PCN: V15-001-476103-OA

Product Change Notice

Change of packaging for all 11mm optical radius of two and three channel codewheels from individual Perspex box to tray design in with 10 cavities.

Current packing of Code wheel using individual Perspex box

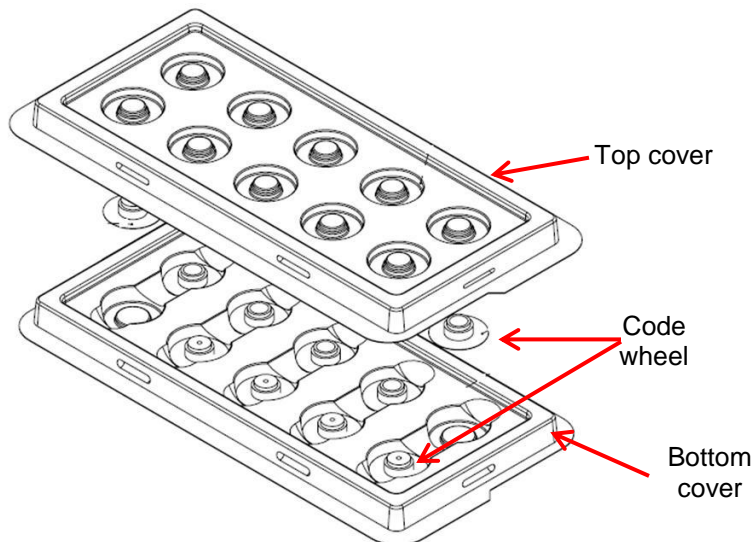
1) Below photo is the current individual Perspex box.

i). Individual Perspex box

Top Cover and Dimensions

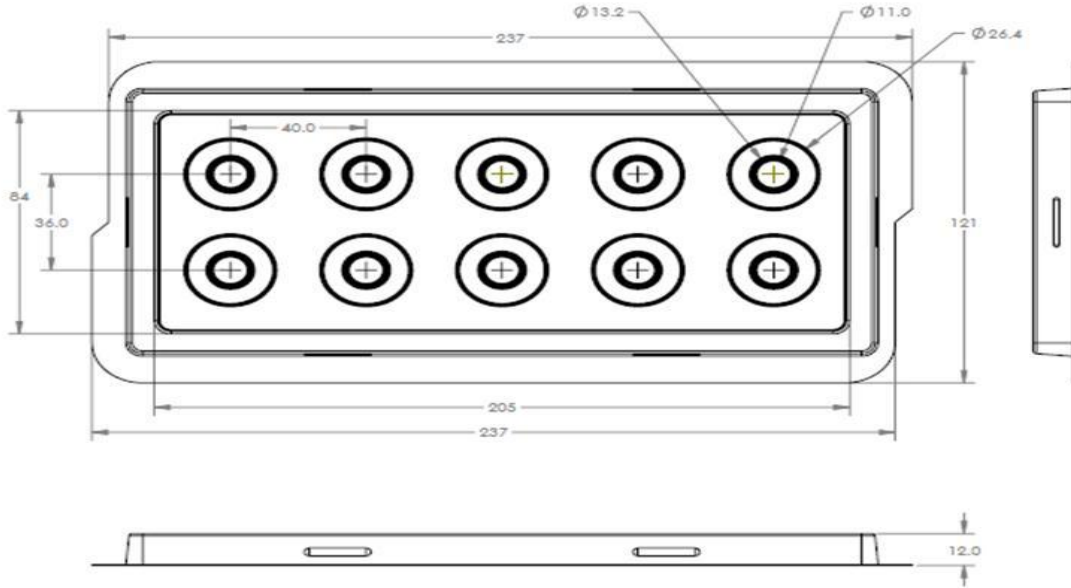
ii). Code wheel packing with 10 units per tray
